TechnologyOne ECM Document Summary

To: annemarie.townsley@jea.co.nz Ref: 24095
Cc:
From: simon.bloomberg@e3scientific.co.nz
Date: 18 July 2024
Subject: Re: RM240352 – Request for review of water quality improvements
for a subdivision under Policy 24.2.4.2 of the QLDC District Plan

From: "Annemarie Townsley" <annemarie.townsley@jea.co.nz>
Sent: Thu, 8 Aug 2024 15:55:43 +1200
To: "Resource Consent" <resourceconsent@qldc.govt.nz>
Cc: "Courtney Briggs" <Courtney.Briggs@qldc.govt.nz>; "Ron Macrae" <ron@cmp.net.nz>
Subject: RM240352 - Macrae - Response to Further Information Request - email 1 of 2
Attachments: Attachment A - Email from Central Pump Services.png, Attachment B - Water Quality Test Results.pdf, Attachment C - Email from Don Moir re ww design.pdf, Attachment D - Water tank locations.pdf, Attachment E - Rockfall Bund Location.pdf, Attachment F - Updated floor areas plan.pdf, Attachment H - e3 memo re water quality.pdf, Further Information Reply 8.8.24.pdf

From: "Annemarie Townsley" <annemarie.townsley@jea.co.nz>
Sent: Thu, 8 Aug 2024 15:56:56 +1200
To: "Resource Consent" <resourceconsent@qldc.govt.nz>
Cc: "Courtney Briggs" <Courtney.Briggs@qldc.govt.nz>
Subject: RM240352 -

**PROPOSED EARTHWORKS
2 LOT SUBDIVISION
832 MALAGHANS ROAD - SHEET 1 OF 3**

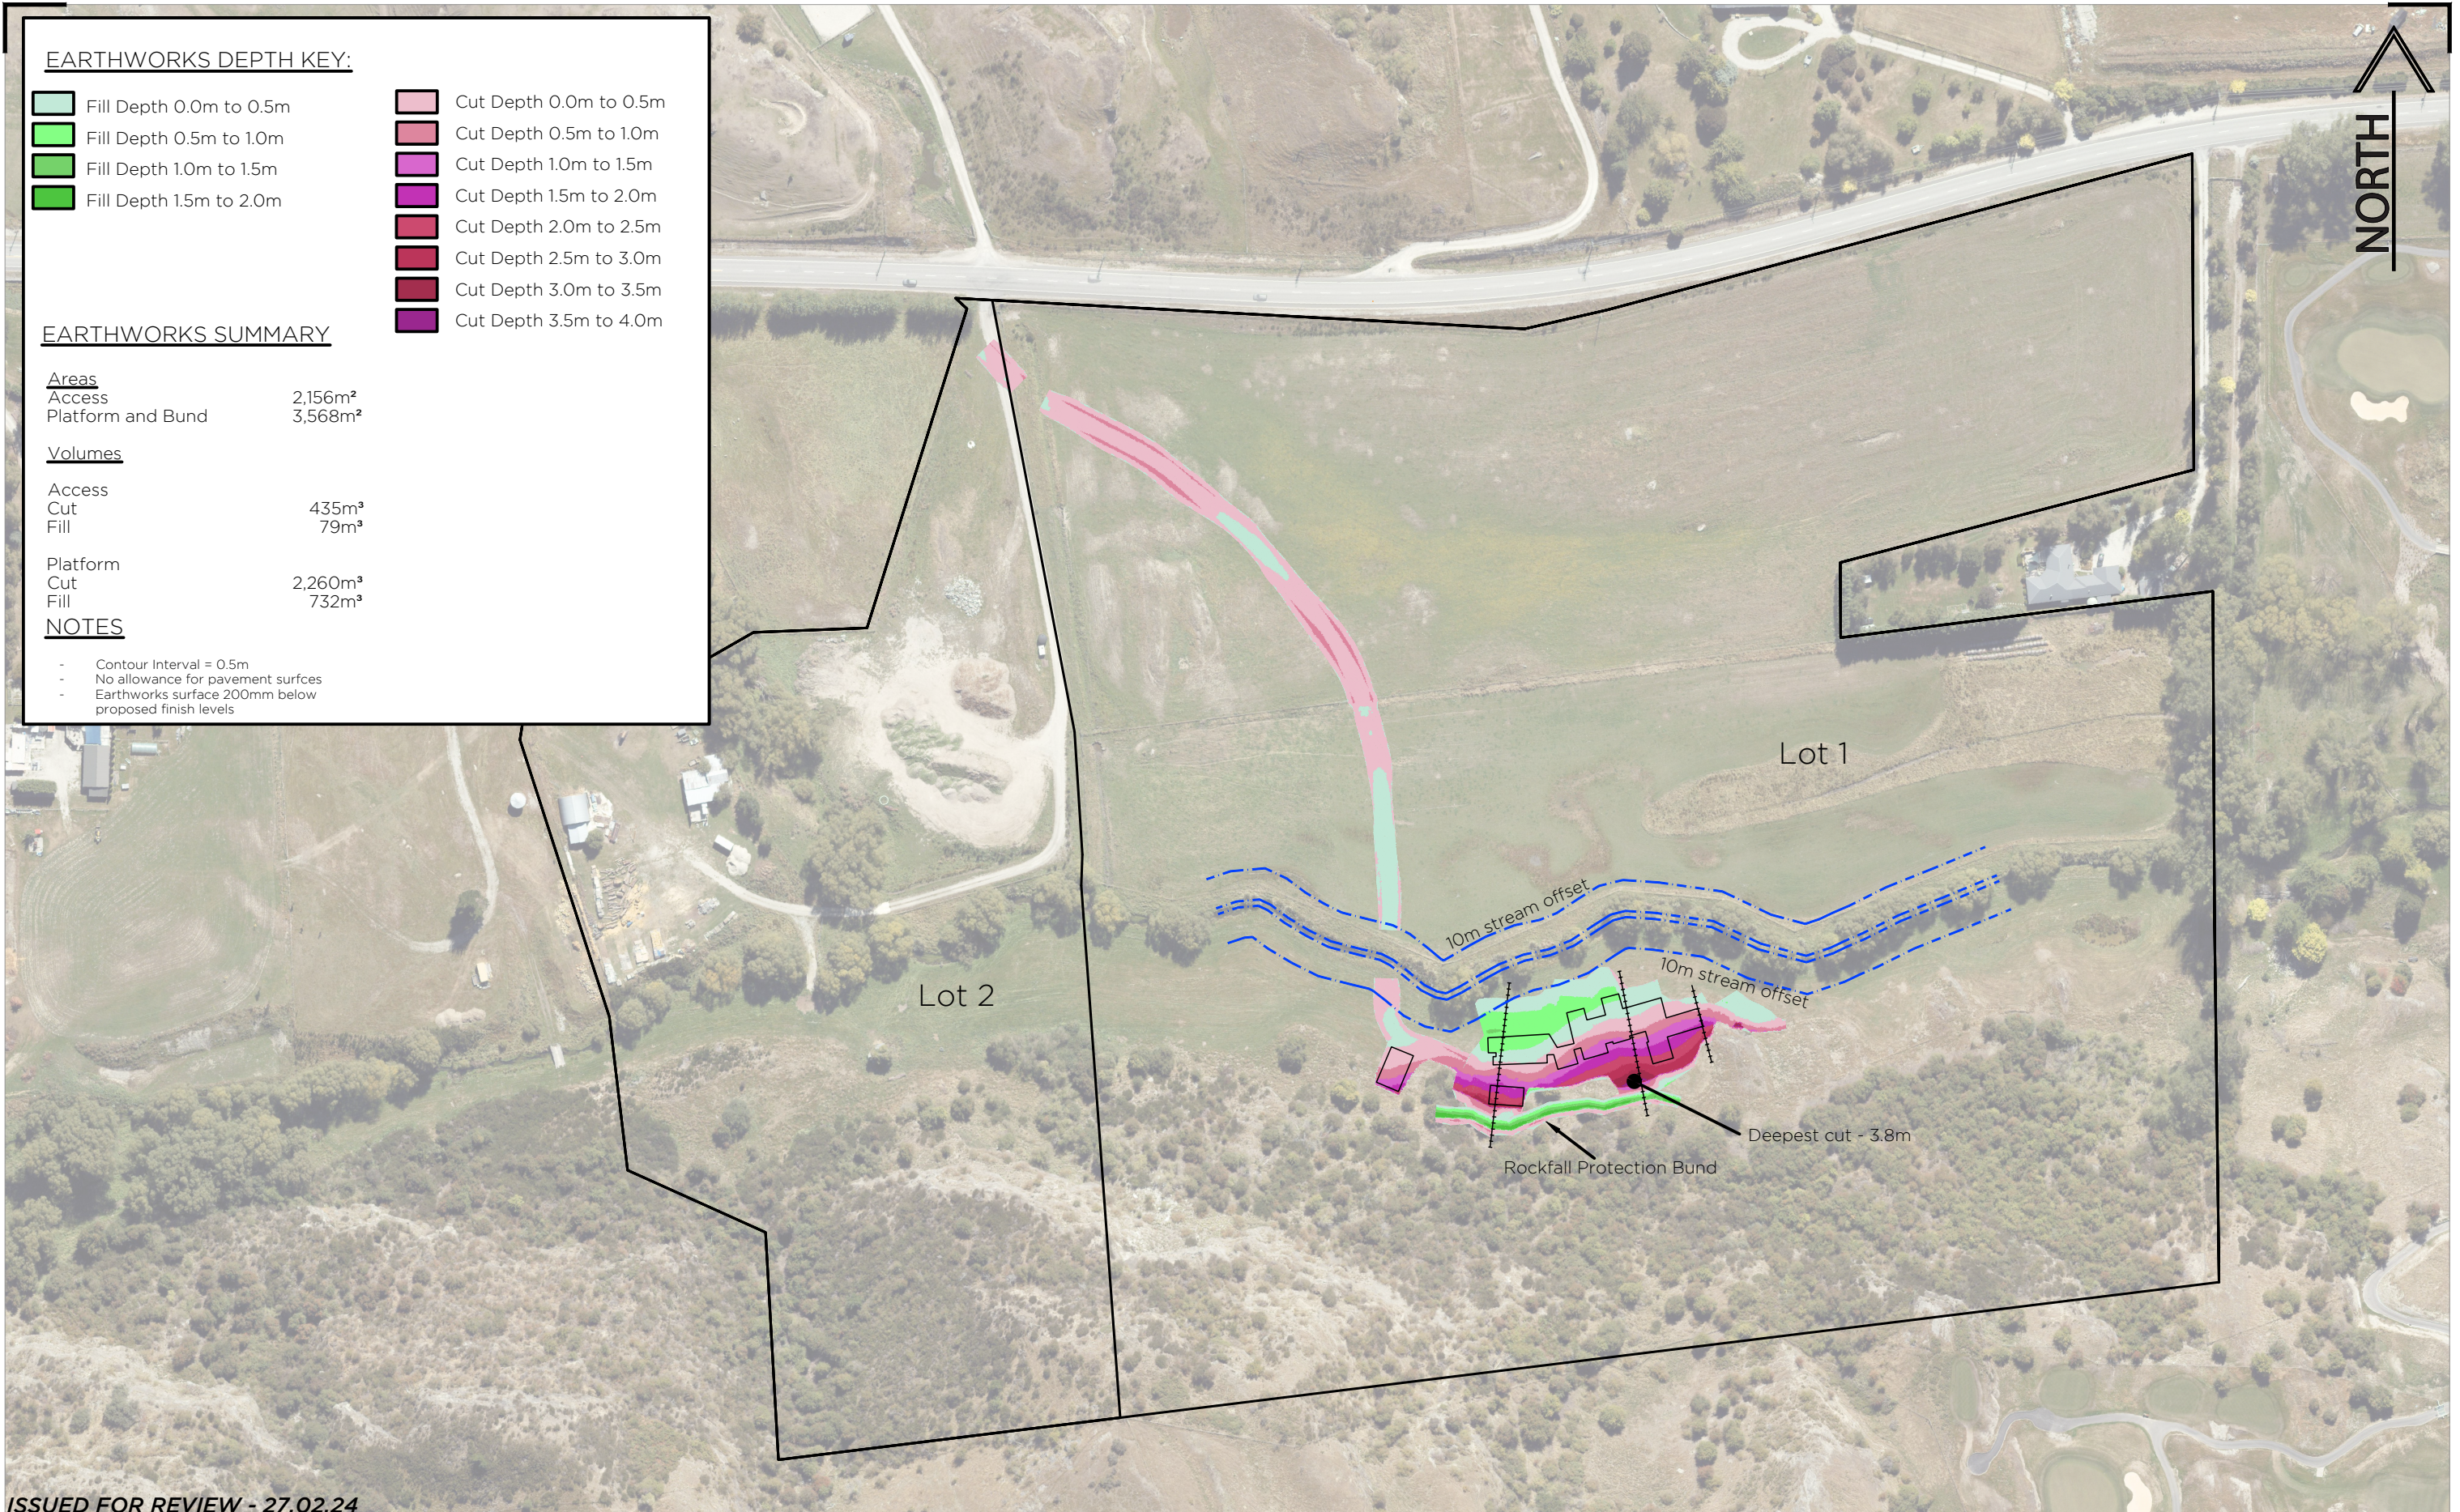
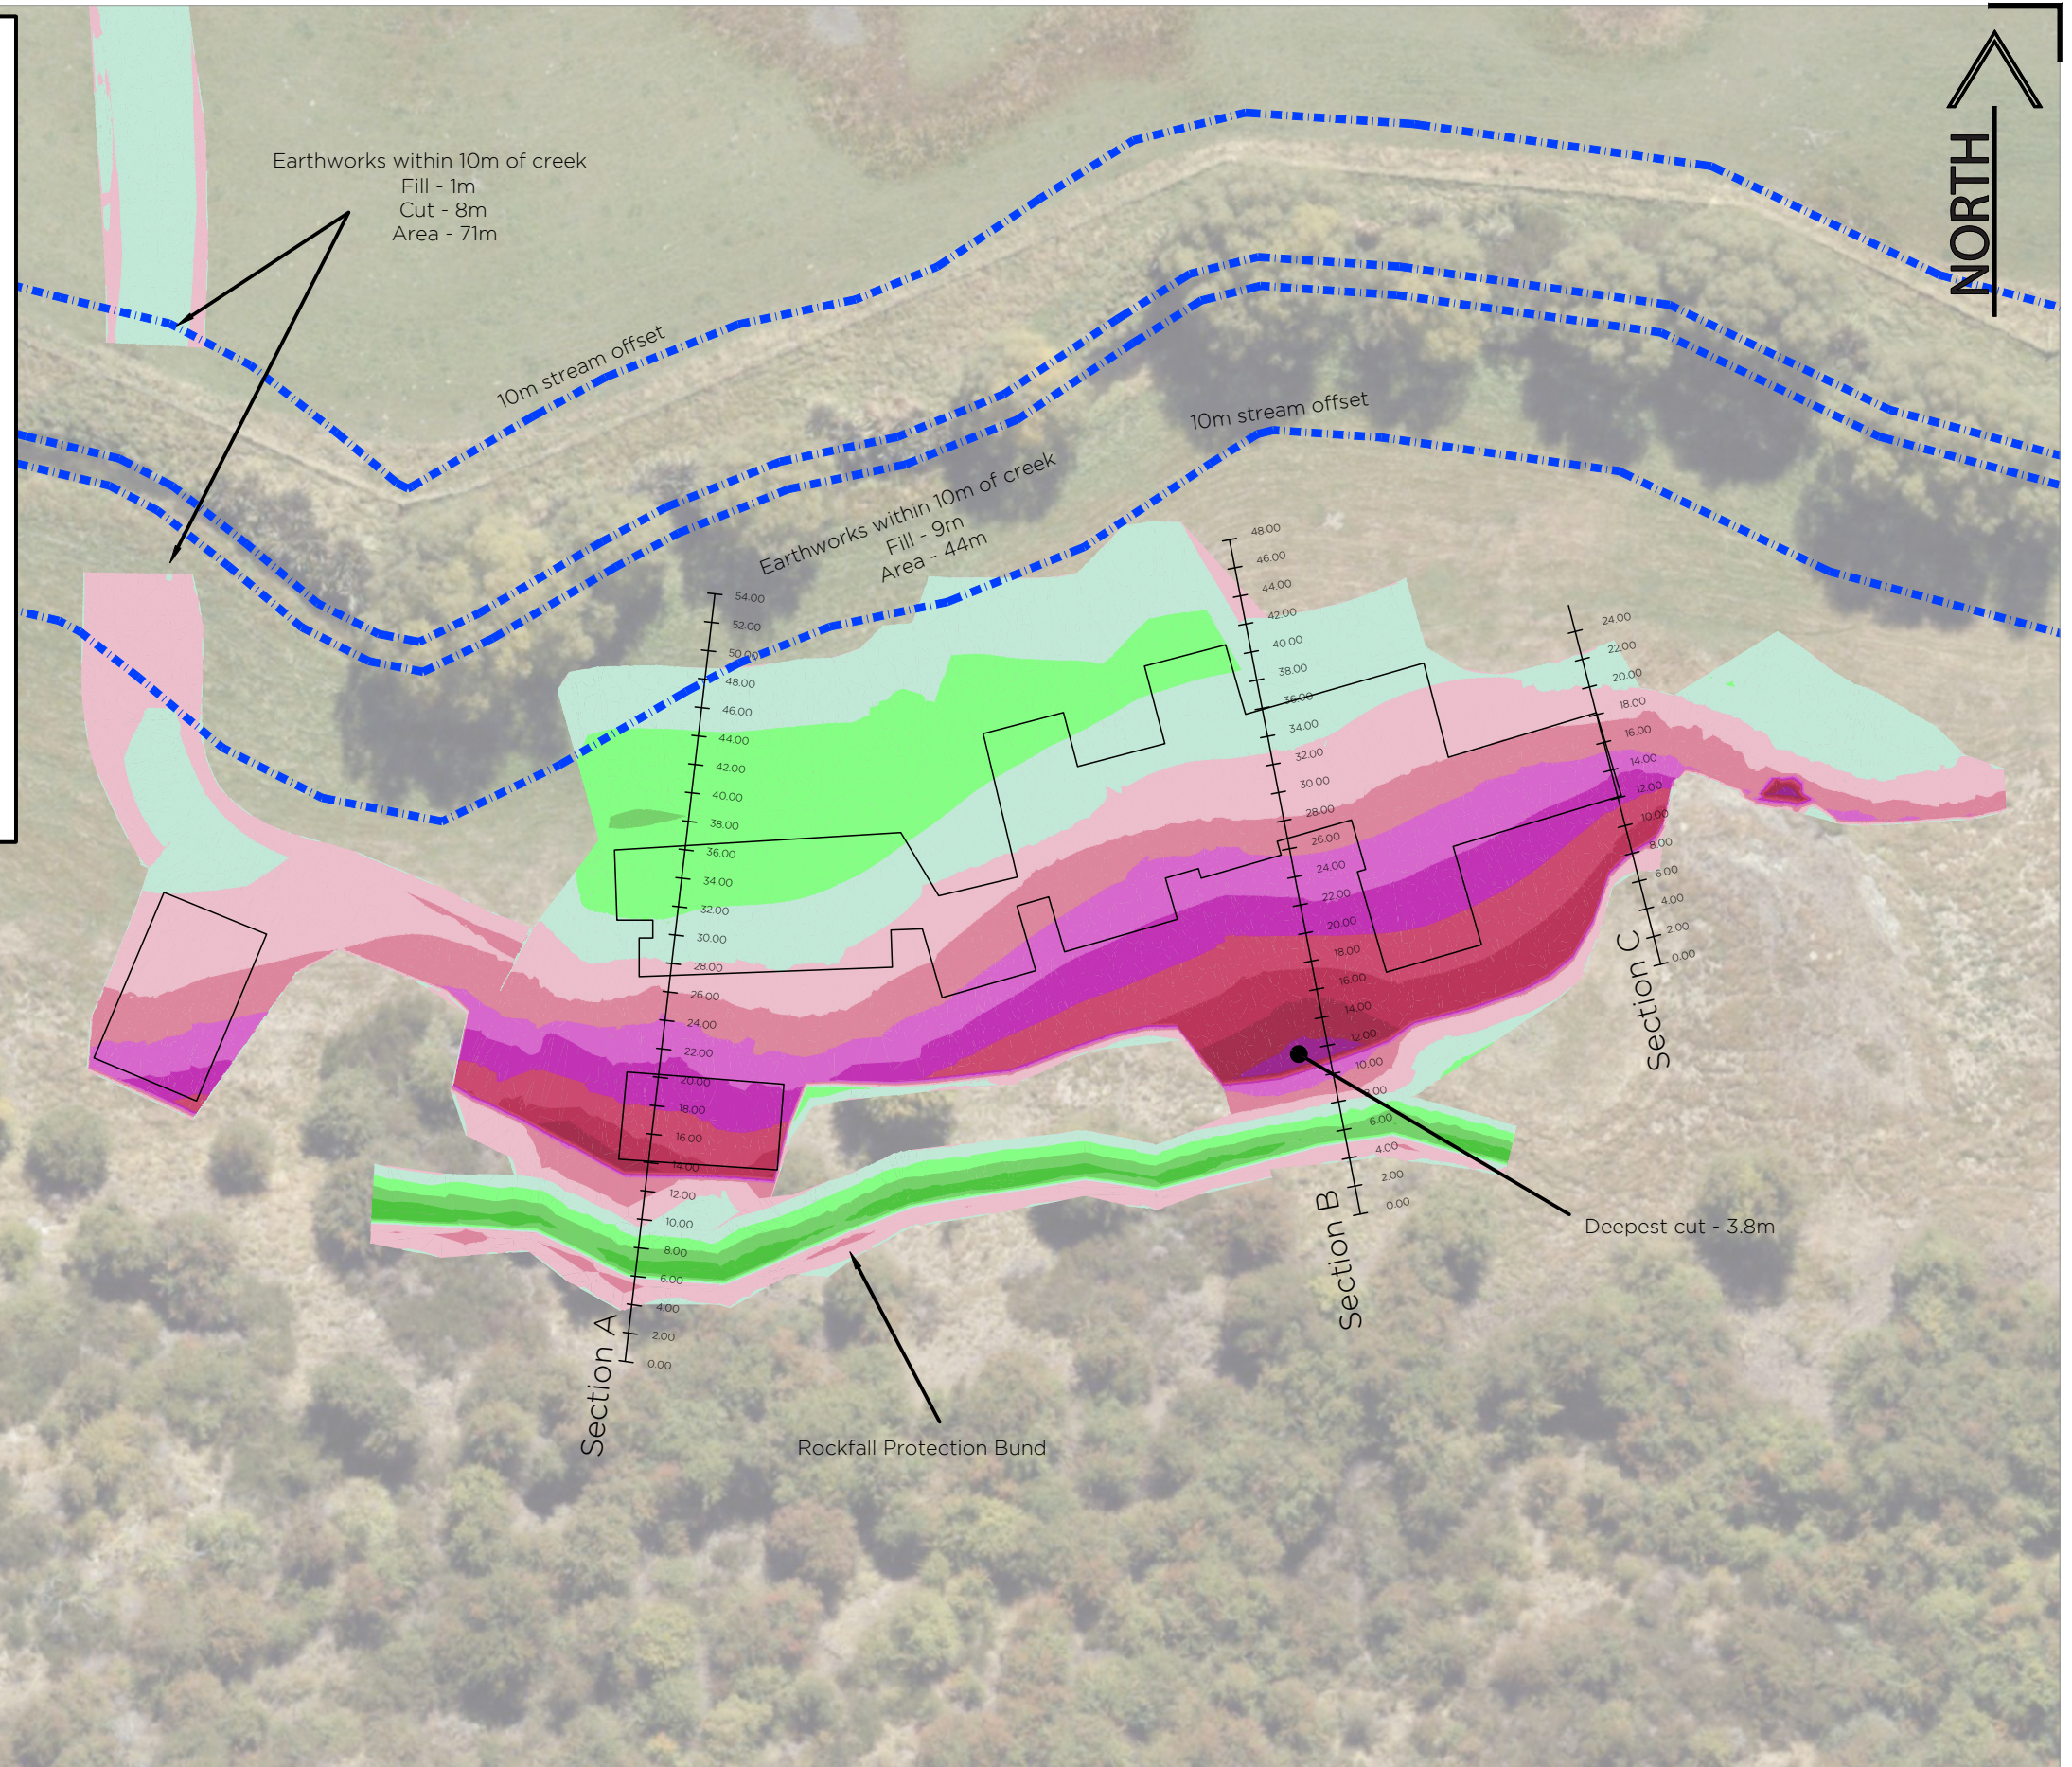
12. Provide separate subdivision and land use earthworks volumes and areas. Please clarify the proposed volume of earthworks within the 10m setbacks of Mill Creek.

See attached updated Earthworks Plans by JEA (**Attachment G**).
